5/17/02**PERMIT**P 516085-BA REPAIR**ON-SITE SEWAGE DISPOSAL SYSTEM
HOWARD COUNTY HEALTH DEPARTMENT
BUREAU OF ENVIRONMENTAL HEALTH****03-300331**

ADDRESS: 1779 Woodstock RoadPROPERTY OWNER: Frank & Ann WoodsSEPTIC TANK CAPACITY (GALLONS): REQ 1500

P 516085-B

TRENCH DATA

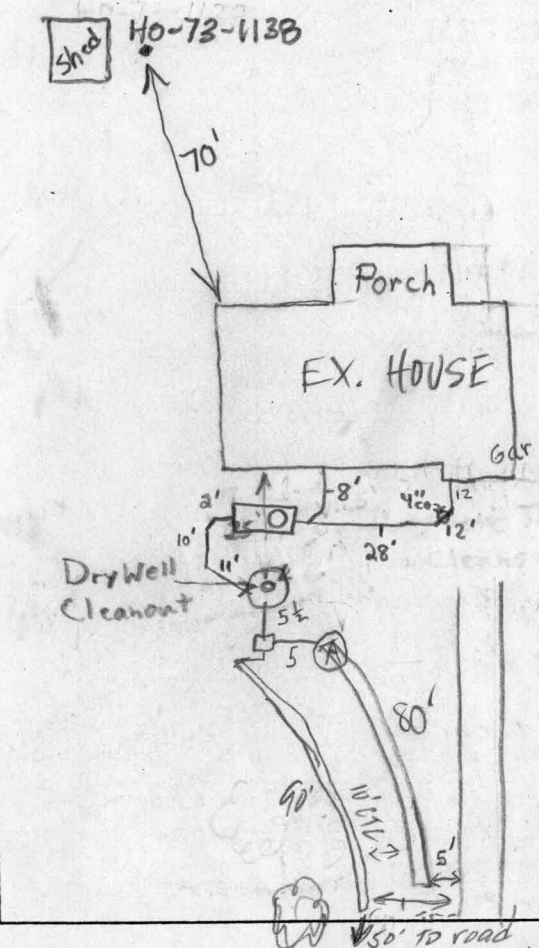
PRE-CONSTRUCTION INSPECTION: 11/2/01 Drywell inlet at 5.5' - 6.0'. Drywell full to about 1.5' below top. To install system for four bedrooms. Existing

INSPECTION COMMENTS: drywell to be used as area for fifth bedroom. Top of drywell is 5.5' to 6' deep. To run two trenches from drywell and try to get 4.25' of stone without going deeper than 10'. Need to replace existing 1000 gallon septic tank with a 1500 gallon tank. BB 12/7/01 80' TRENCH DONE, CONTINUE MR 12/12/01 Second trench installed, OK to cover. Tank still needs to be increased in size SD

4/30/02 2000 gal TS set. 5/17/02 - DRAWING SUBMITTED FROM CONTRACTOR - RE: HOUSE CONN.
